ADDENDUM NO. 1

**Administration Building Renovation Re-bid
Compton Community College District**

tBP Project. No. 20987.00

tBP/ARCHITECTURE

drawing no.:
9.11
 drawing of

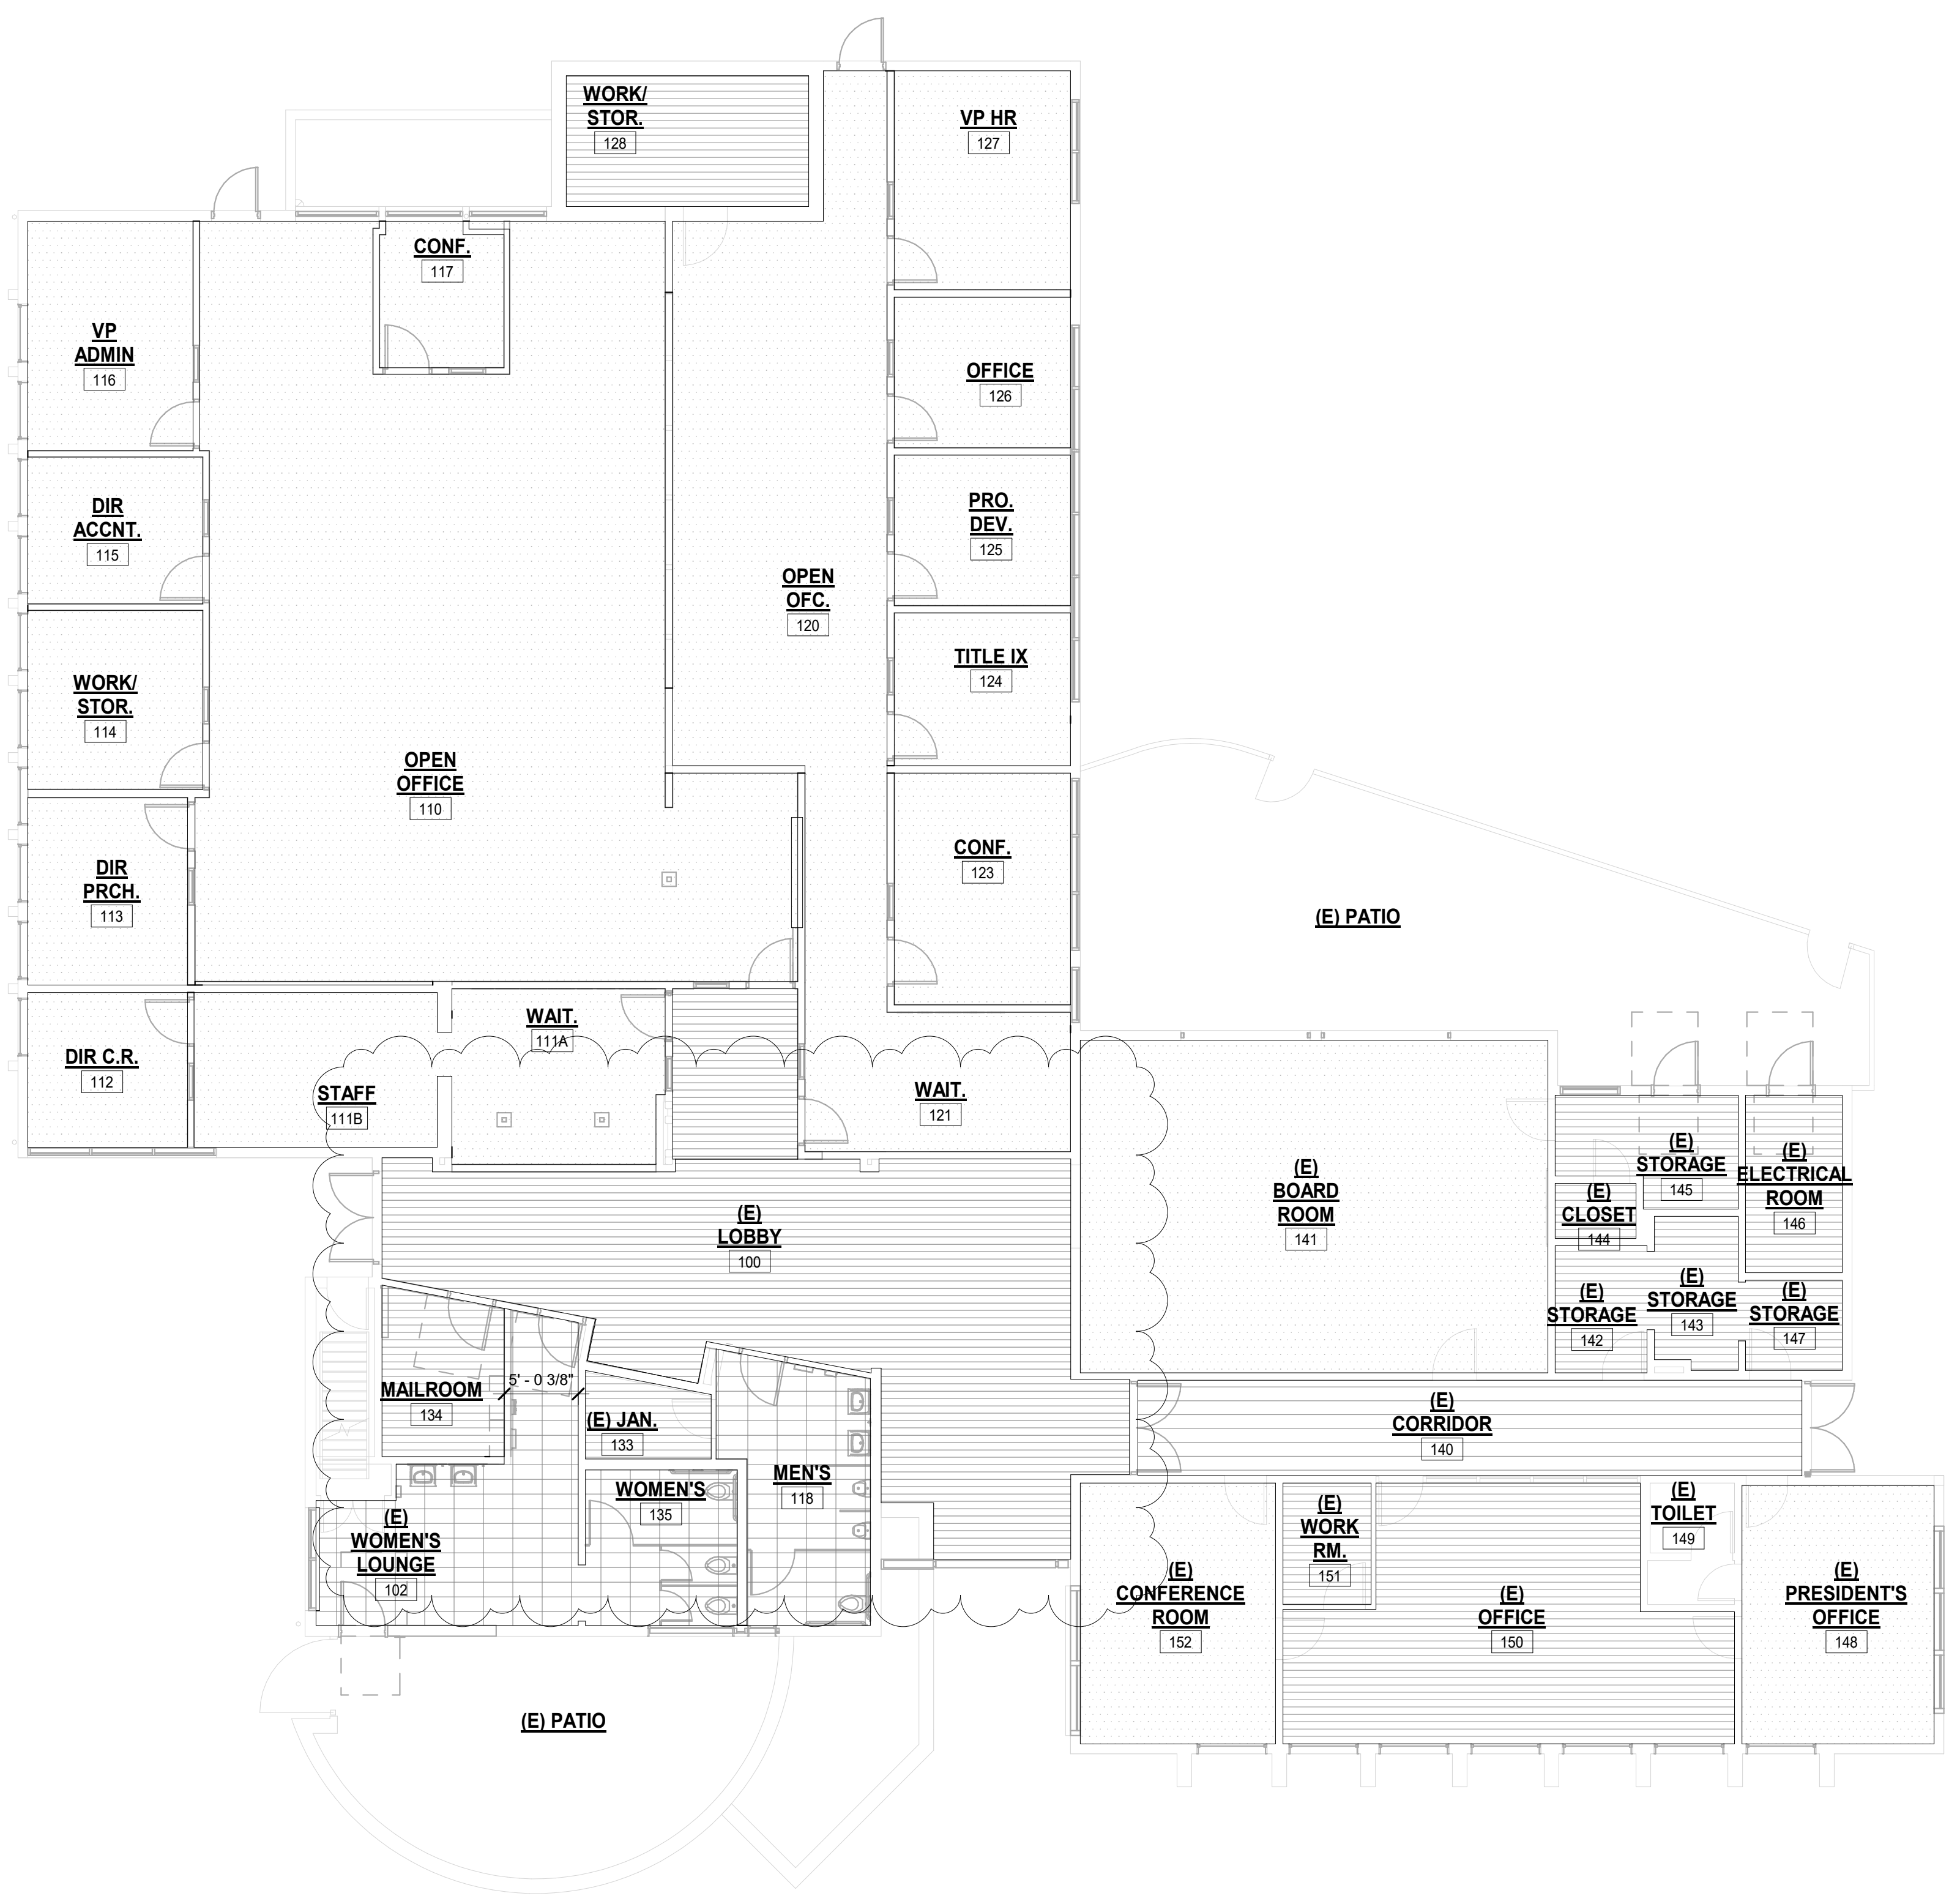
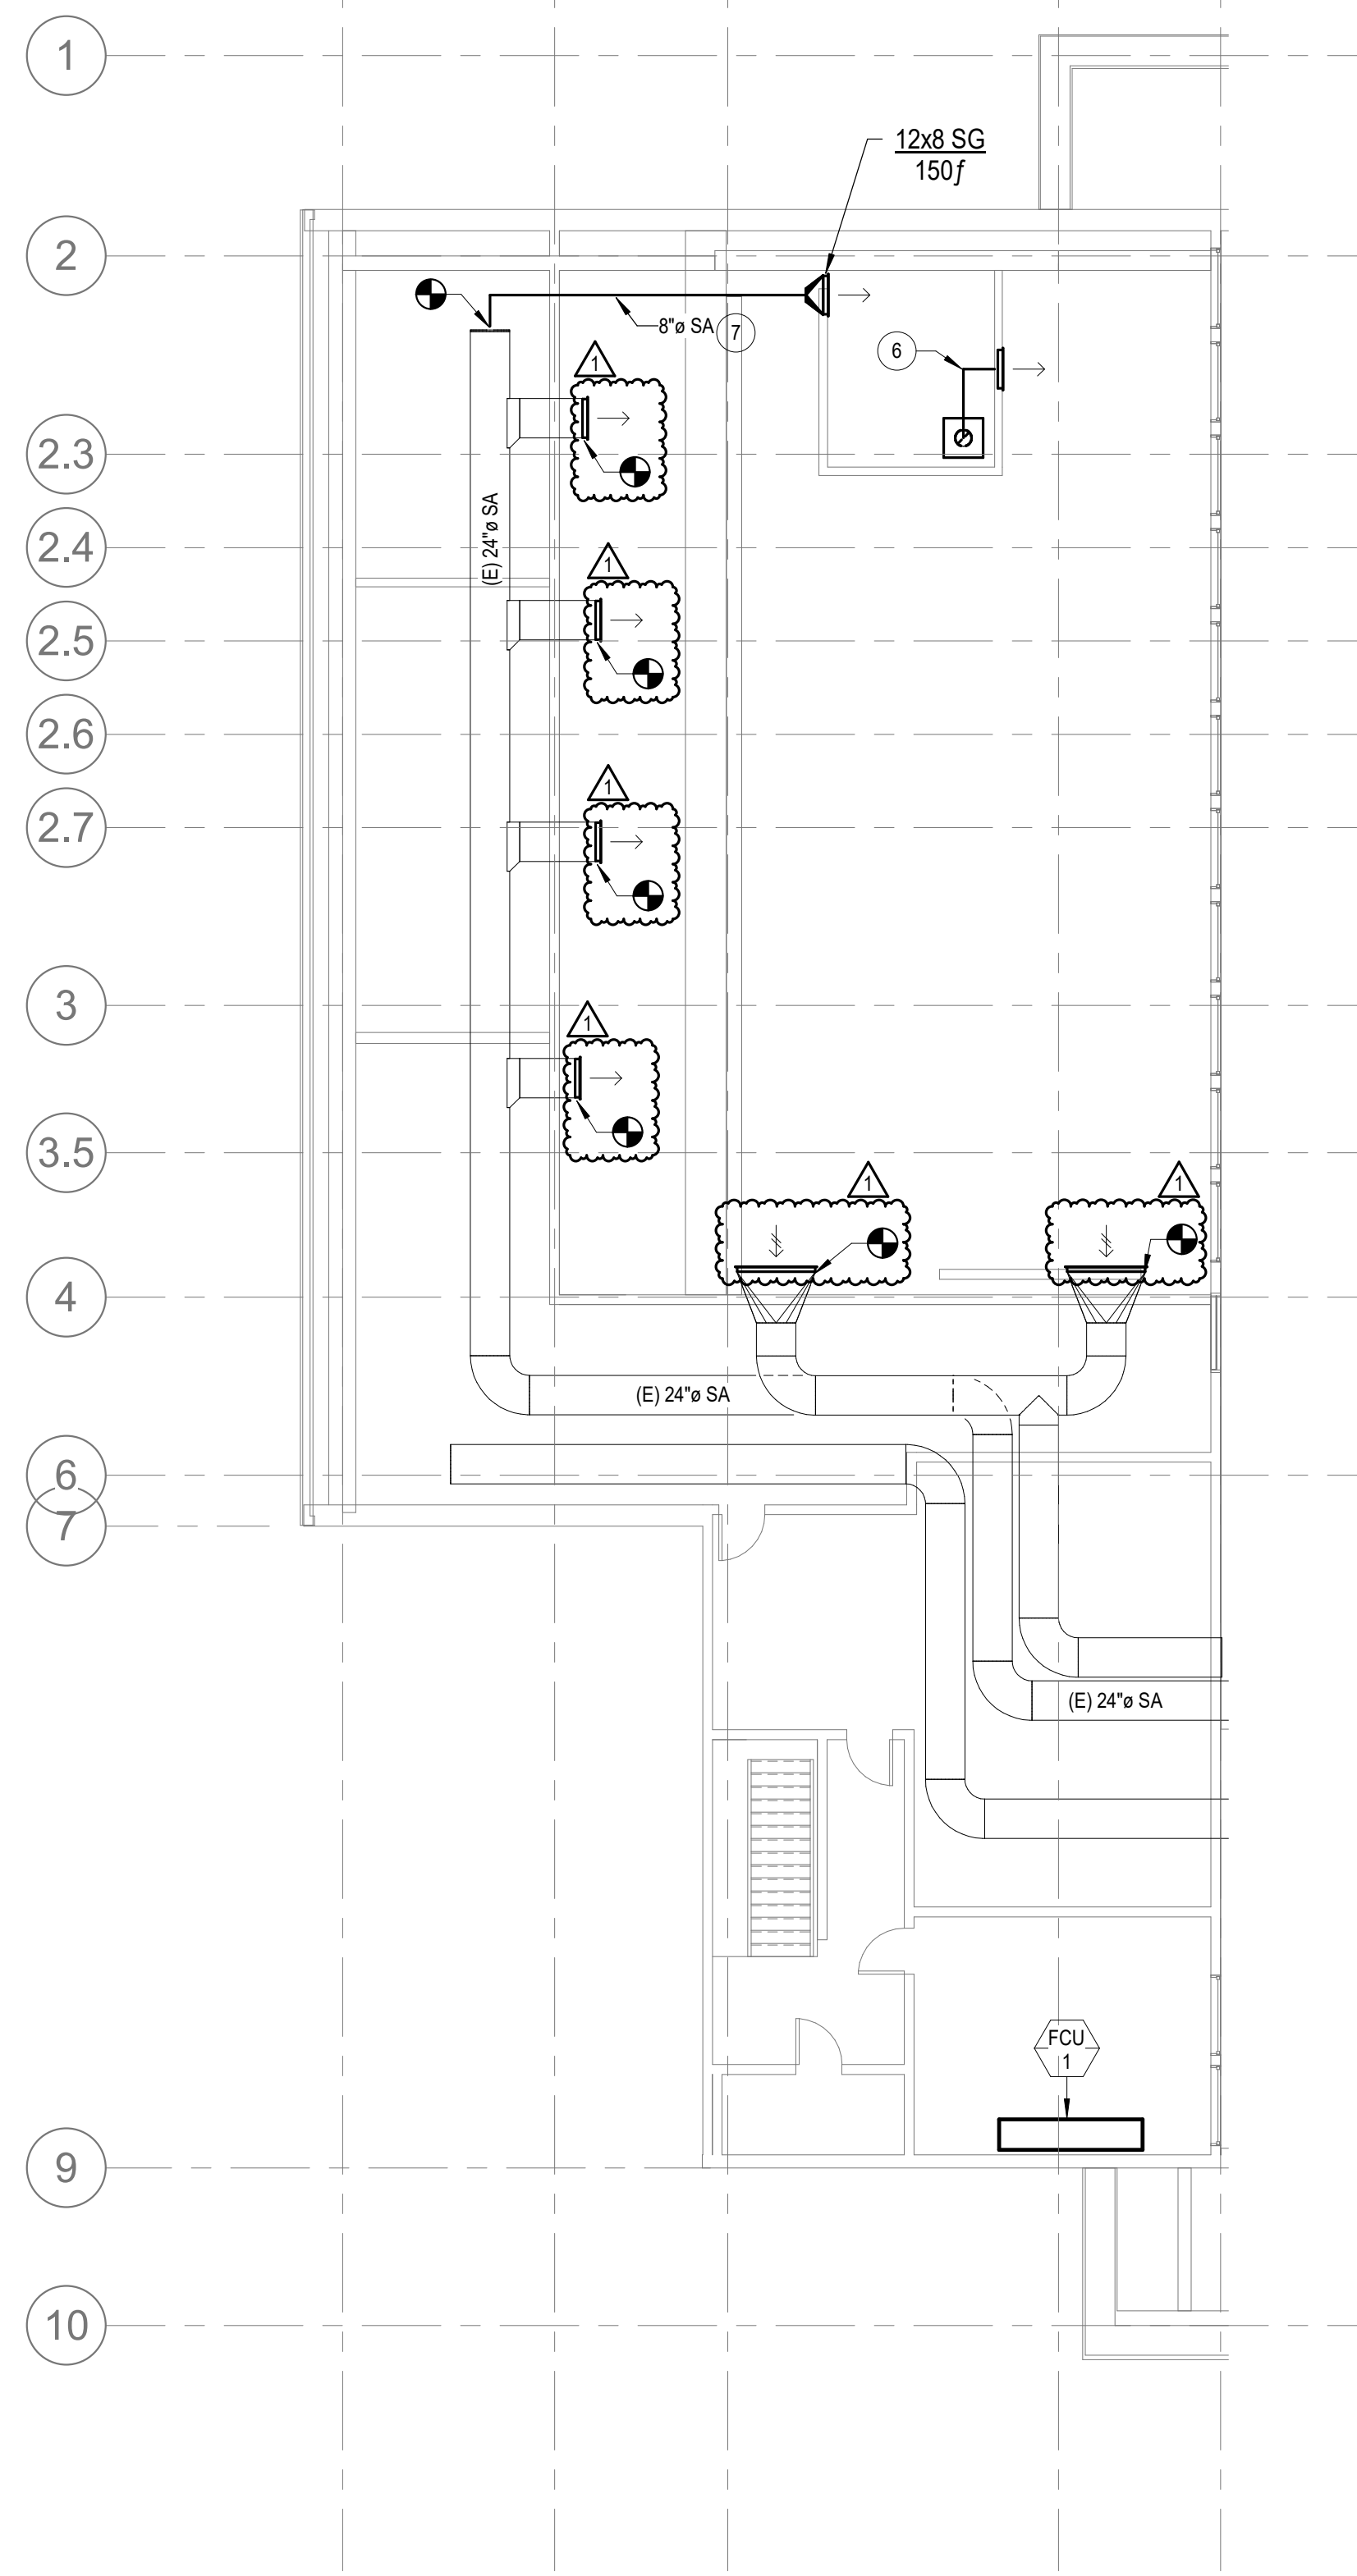
18. **Revised SHEET 9.11 FLOOR FINISH PLAN**
- a. Revised Lobby area floor finish to be LVT instead of Terrazzo.
 - b. Removed Carpet floor Finish and LVT2 to be all replaced by LVT-1.
See attached revised Full size sheet identifying revisions included as part of this addendum.
